Subject: FEBEG's comments on ELIA's public consultation on the rules on the organization of the Transfer of Energy and the FSP Contract DA/ID

Date: 19 November 2020

Pass-through definition

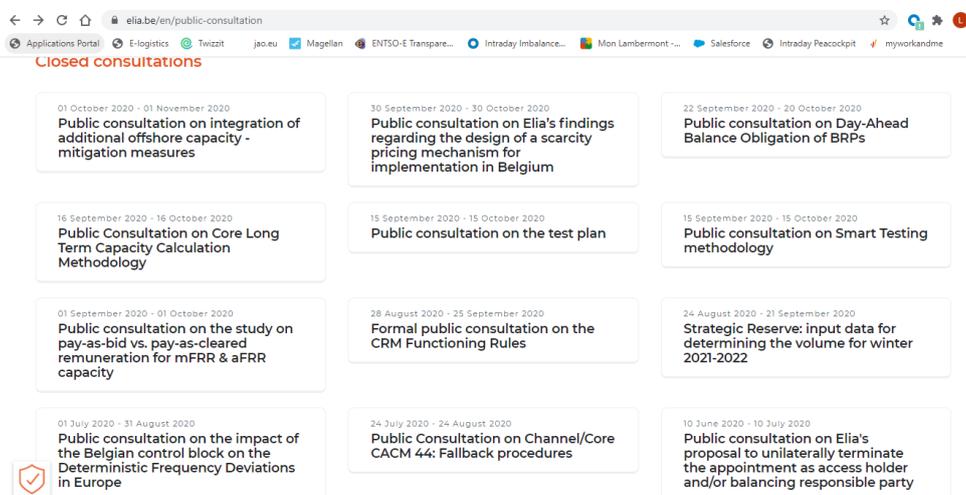
From the redefinition of pass-through contract, the CREG intends to narrow the scope of pass-through to those customers that are only exposed to an imbalance price; hence, leaving the customers exposed to day-ahead and not to imbalance at the Transfer of Energy scheme. CREG mentions that this is the result of the upcoming entry into force of Transfer of Energy for DA & ID.

- **For activations on DA:** FEBEG does not see the added value of narrowing the scope as a customer that makes an activation on the DA market would immediately benefit from it through its supply contract. FEBEG does not see the point in artificially waiving this DA exposure during the activation and complexifying the settlement process. This settlement would have been simple and crystal-clear, and limited to the couple customer-supplier/BRP.
- **The amendment imposed by CREG will bring additional complexity as there will be instead multiple settlement processes:**
 Settlement BSP – Customer
 Settlement BSP – Supplier/BRP
 A correction of perimeter by TSO
 An ad-hoc settlement (specific to the activation) Customer – Supplier/BRP

Questions: Who will compensate for the operational costs being incurred by this additional complexity? Can the conclusions of the cost-benefits analysis be shared with the market parties?

- **For activations on balancing market:** The immediate effect of this amendment will be that the amount of customers where a bilateral agreement BSP-BRP is needed or where the regulated price formula is applicable will increase. Again, comparing with the current situation **FEBEG does not see any added value for the balancing market, BRP's/ Suppliers, the Customers, and nearly all BSP's**. The complexity explained above also applies here. Assuming ToE DA-ID has an added value, it seems disproportionate to review the whole pass-through definition for balancing market products.

- **For activation on ID market:** In the unlikely event a Customer does want to valorize its flexibility on ID market but choose a supply contract limited to DA exposure (ID and imbalance exposure contract are available on the shelf) and appoints a BSP to valorize its flexibility, FEBEG acknowledges that the current pass-through definition is not suited. FEBEG fears that a very specific case (can such a concrete case already be identified today, which would require this complex solution?) triggers a disproportionate answer namely applying a new pass-through definition to DA, ID & balancing market. Here, **FEBEG can only recommend that CREG limits the amendments to ID activation only and/or that customers choose for a supply contract with exposure up to imbalance**.
